## PIC24F16KL402 Family Silicon Errata and Data Sheet Clarification

The PIC24F16KL402 family devices that you have received conform functionally to the current Device Data Sheet (DS30001037C), except for the anomalies described in this document.

The following typographic corrections and clarifications are to be noted for the latest version of the device data sheet (DS30001037C):

In Register 23-6: FPOR: Reset Configuration Register, the description for BORV<1:0> has been updated. The change is shown in **bold** below:

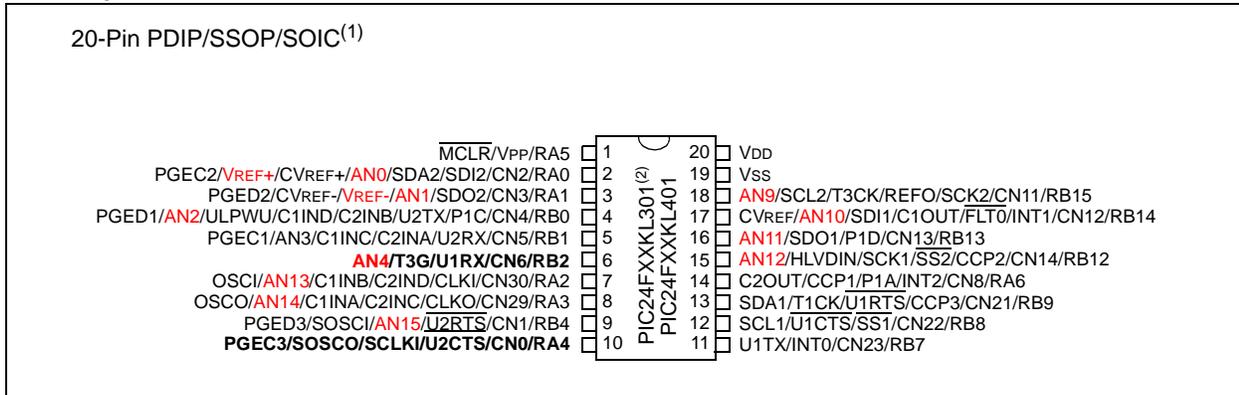
bit 6-5 BORV<1:0>: Brown-out Reset **Voltage Threshold** bits<sup>(2)</sup>

11 = Brown-out Reset is set to the low trip point  
10 = Brown-out Reset is set to the middle trip point

01 = Brown-out Reset is set to the high trip point  
00 = Downside protection on POR is enabled (Low-Power BOR is selected)
